#### **Addendum 3 – Regulation No. 4**

#### **Revision 3 - Amendment 1**

#### **Uniform provisions concerning the approval of devices for the illumination of rear registration plates of power-driven vehicles and their trailers**

### Measurement points for test purposes

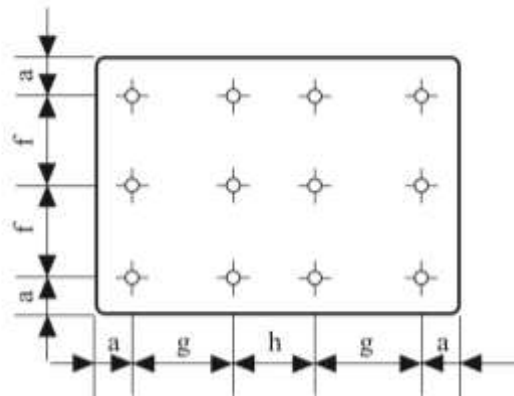
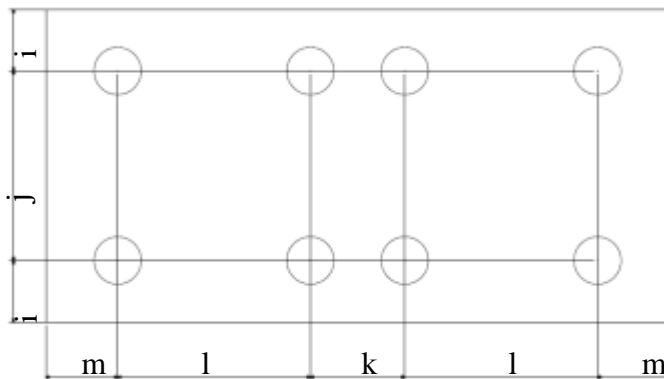
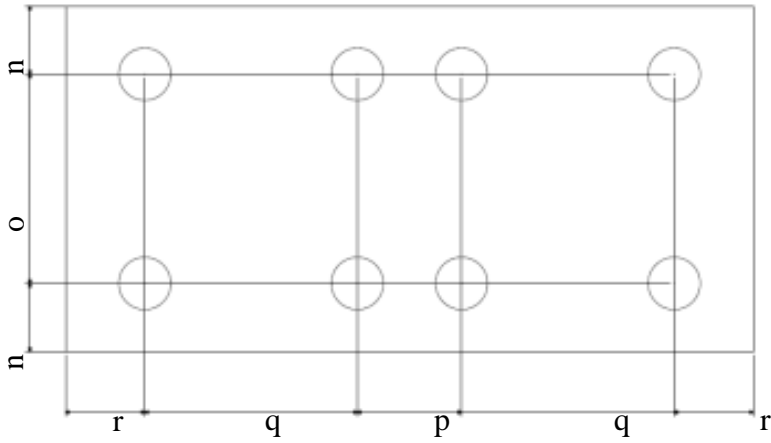
Annex 3, amend to read:

Category 1a (340 x 240 mm)

Category 1b (520 x 120 mm)

Category 1c (255 x 165 mm)

Category 2a (330 x 165 mm)

Category 2b (440 x 220 mm)
